Product Change Notification

Product Group: Film capacitors/ February 25, 2009/PCN-FC-007-2008 Rev 1

F1772 - 2 series X2 capacitors upgrade to 310 Vac, 110°C and miniaturization of dimensions

Annexure 1 :

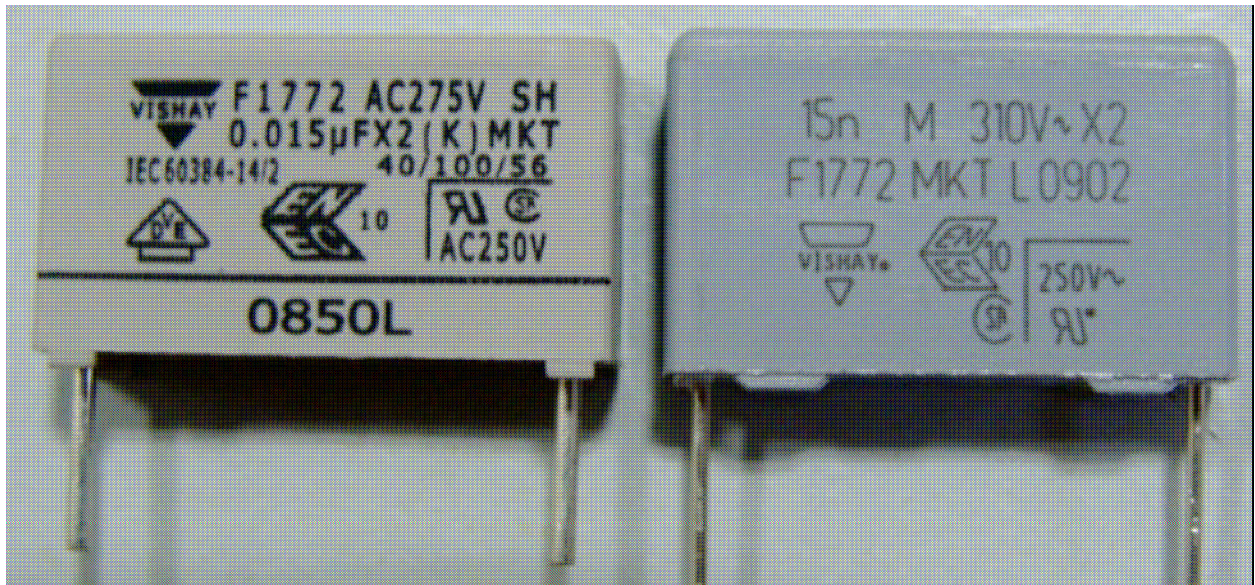
Voltage rating: For F1772 – 2: Increases from 275 Vac to 310 Vac.

Voltage: 310 V~ will be marked on capacitor and label. Change in dimensions and lead diameter
See annexure.
